FLIGHT CONTROLS - ELEVATOR TRIM PUSH-PULL ROD HARDWARE REPLACEMENT

To replace the hardware securing the elevator trim push-pull rod.

This service bulletin provides instructions to replace the hardware connecting the elevator trim push-pull tube to the elevator trim actuator and elevator trim tab.

Figure 1. Elevator Push-Pull Rod Hardware Replacement (Sheet 1)

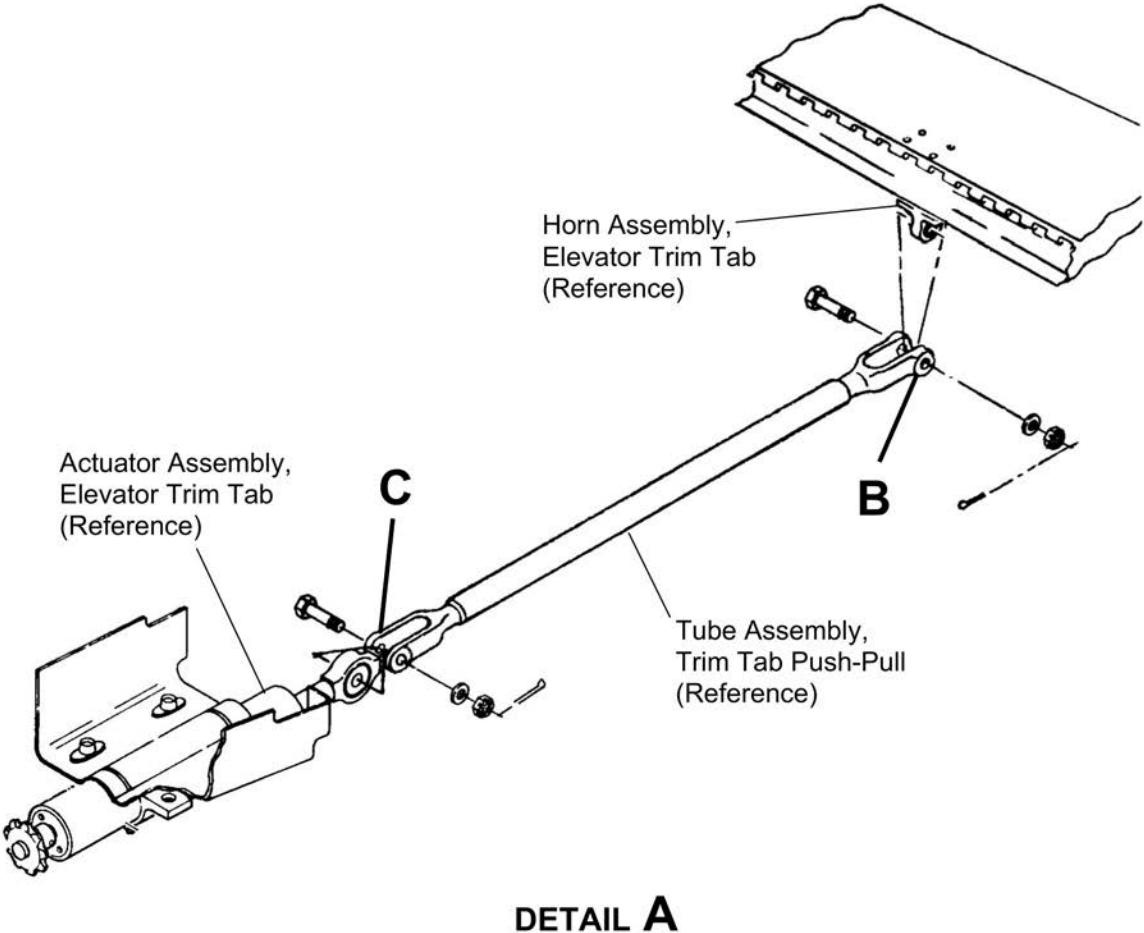
1. Prepare the airplane for maintenance.
 - A. Make sure that the airplane is electrically grounded.
 - B. Make sure that all switches are in the OFF/NORM position.
 - C. Disconnect electrical power from the airplane.
 - (1) Disconnect the airplane battery.
 - (2) Disconnect external electrical power.
 - D. Attach maintenance warning tags to the control columns and elevator trim wheel that have "**DO NOT MOVE ELEVATOR OR ELEVATOR TRIM - MAINTENANCE IN PROGRESS**" written on them.
2. (Refer to Figure 1, Sheet 1 and Sheet 2.) Remove the nut, washer and bolt from the elevator trim tab to push-pull tube and discard the hardware.

3. (Refer to Figure 1, Sheet 1 and Sheet 2.) Install the NAS464P3-8 Bolt, NAS1149F0332P Washer, MS17826-3 Nut and MS24665-132 Cotter Pin in the elevator trim tab to push-pull tube.

4. (Refer to Figure 1, Sheet 1 and Sheet 2.) Remove the nut, washer and bolt from the elevator trim actuator to push-pull tube and discard the hardware.

5. (Refer to Figure 1, Sheet 1 and Sheet 2.) Install the NAS464P3-8 Bolt, NAS1149F0332P Washer, MS17826-3 Nut and MS24665-132 Cotter Pin in the elevator trim actuator to push-pull tube.

DETAIL B

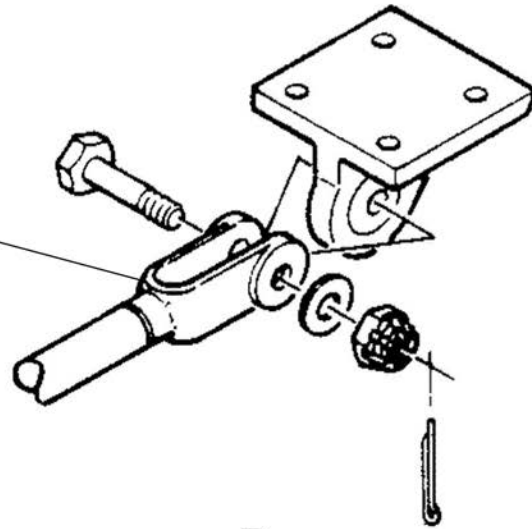
CAUTION: Use of the correct cotter pin, part number MS24665-132, is critical in this installation. Use of a different cotter pin could result in the hardware becoming loose.

- NAS464P3-8
- Bolt
- NAS1149F0332P
- Washer
- MS17826-3
- Nut
- MS24665-132
- Cotter Pin
- (1 Each Required)

DETAIL C

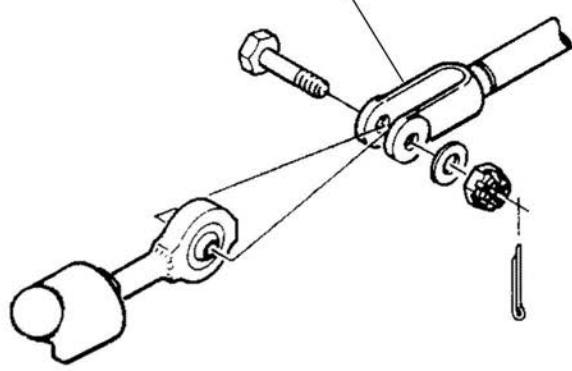
CAUTION: Use of the correct cotter pin, part number MS24665-132, is critical in this installation. Use of a different cotter pin could result in the hardware becoming loose.

- NAS464P3-8
- Bolt
- NAS1149F0332P
- Washer
- MS17826-3
- Nut
- MS24665-132
- Cotter Pin
- (1 Each Required)
